Re: Mesa Del Sol Elevated Water Reservoir Grading and Drainage Plan
Engineer's Stamp dated 7-24-07 (R16/DA3004)

Re: Mesa del Sol Elevated Water Tank Grading and Drainage Plan (R16/D096)
Engineer's Stamp dated 7-9-07 (Resubmitted Engineer's Stamp dated 7-24-07)

Re: Mesa Del Sol Elevated Water Tank Grading and Drainage Plan
Engineer's Stamp dated 7-9-07 (R16/D096)

CITY OF ALBUQUERQUE
DEPARTMENT OF MUNICIPAL DEVELOPMENT
MESA DEL SOL
ELEVATED WATER RESERVOIR
SITE GRADING, DRAINAGE, AND UTILITY PLAN

CITY PROJECT NO. DRB	ZONE MAP NO. R-16-Z	SHEET 5A	OF 5
-------------------------	------------------------	-------------	---------

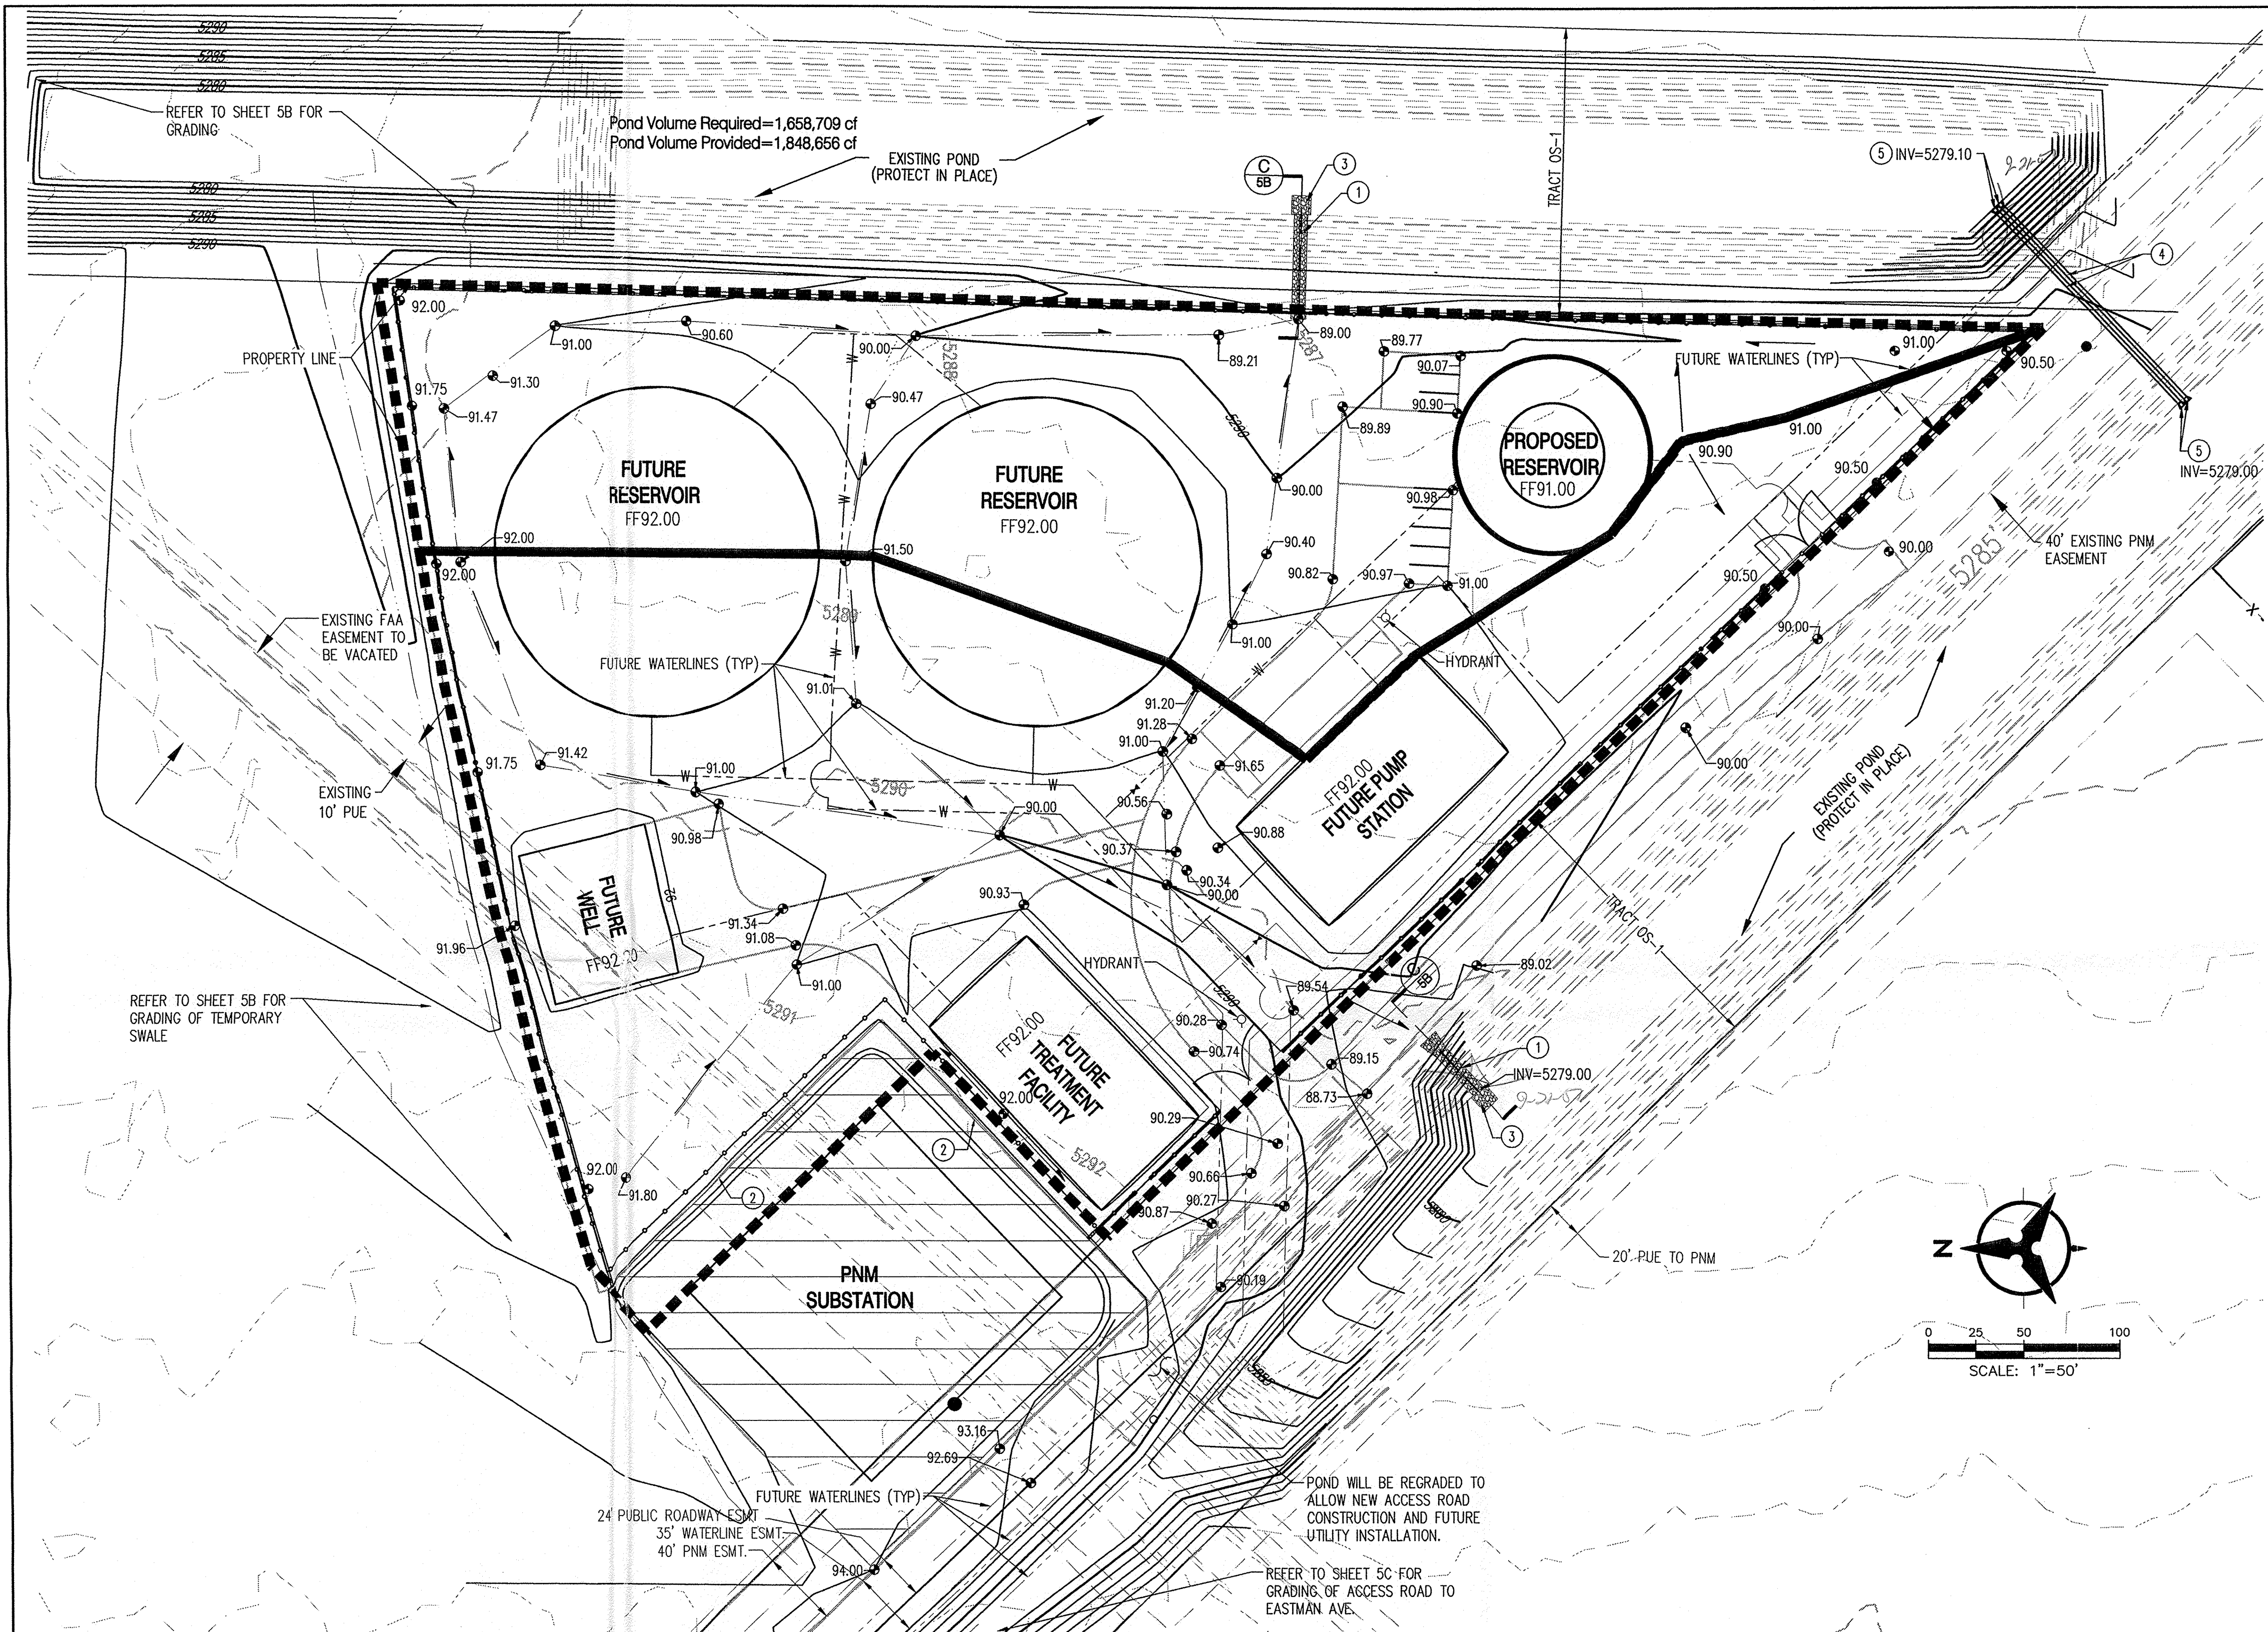
- More information is required before the ponds can be graded and related infrastructure can be built.
 - Inverts are required for the 2-36" RCP storm drain connecting the two ponds. In addition show the pipe ends in both ponds.
 - Which COA STD SPEC are you planning on using for the Rip Rap rundowns? What is Type VL? Is "1" thick" a typo?
 - Provide an invert for the rundown into the south pond.
 - Provide new volumes of the two ponds.
- It appears that grading of the site is integral with grading of the ponds and since more information is required before grading the ponds, the site should not be graded until approval is given to grade the ponds.

1. The access road to the site has been revised on all sheets. The access road is currently located east of the trail. In addition the power pole has been shown correctly on the Site Access Plan. The Grading Plan shows this pole in the correct location.
2. A maintenance agreement will be obtained by PNM/ABCWAU for the access road.
3. Inverts for the 2-36" RCP storm drain connecting the regional retention pond together was provided.
4. The rip rap specification call-out was revised and corrected.
5. An invert for the rundown in the south pond was provided.
6. Volumes for the design volume required and the volume provided have been shown on sheet

CITY PROJECT NO. DRB	ZONE MAP NO. R-16-Z	SHEET 5C	OF 5
-------------------------	------------------------	-------------	---------

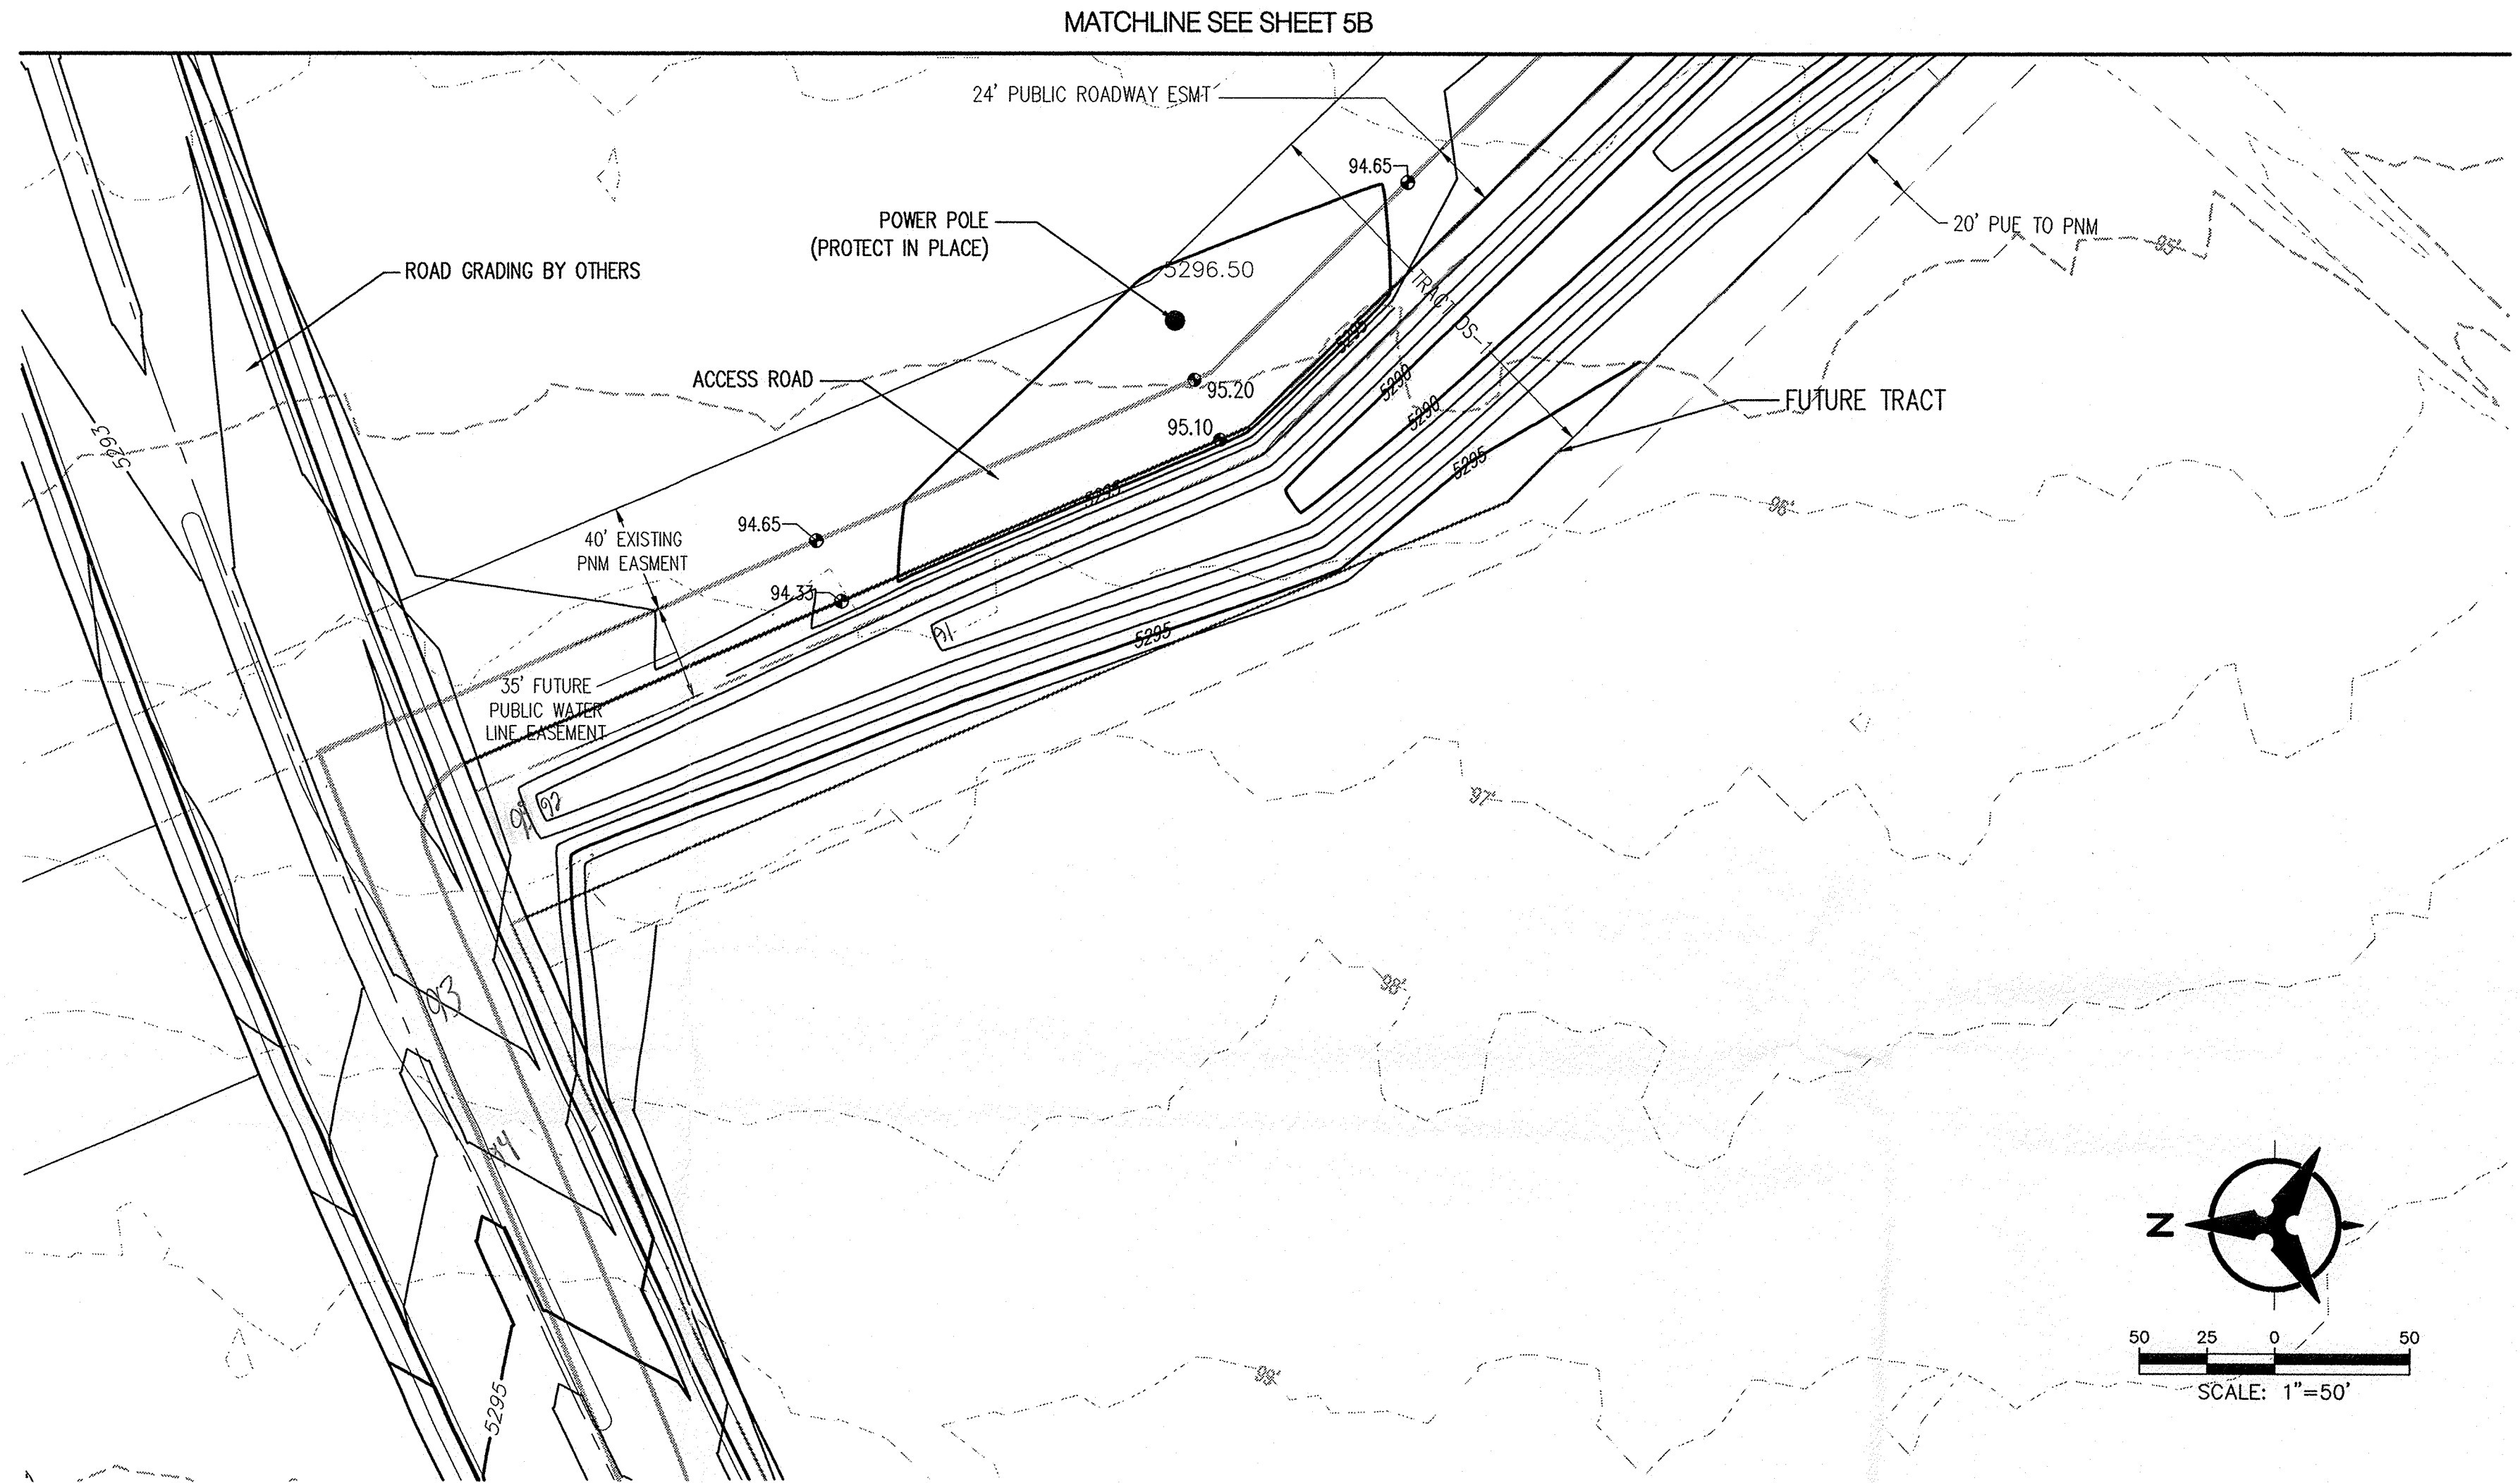
- The Site Access Plan shows the access road in the bottom of the swale leading to the regional pond, while the grading plan shows the access road on the east shoulder of the swale. The location east of the swale is preferable. The Site Access Plan also shows the power pole in the drainage tract, whereas the Grading Plan depicts it outside of the drainage tract.
- The access road in the drainage tract should be maintained by PNM/ABCWAU. A maintenance agreement is required.
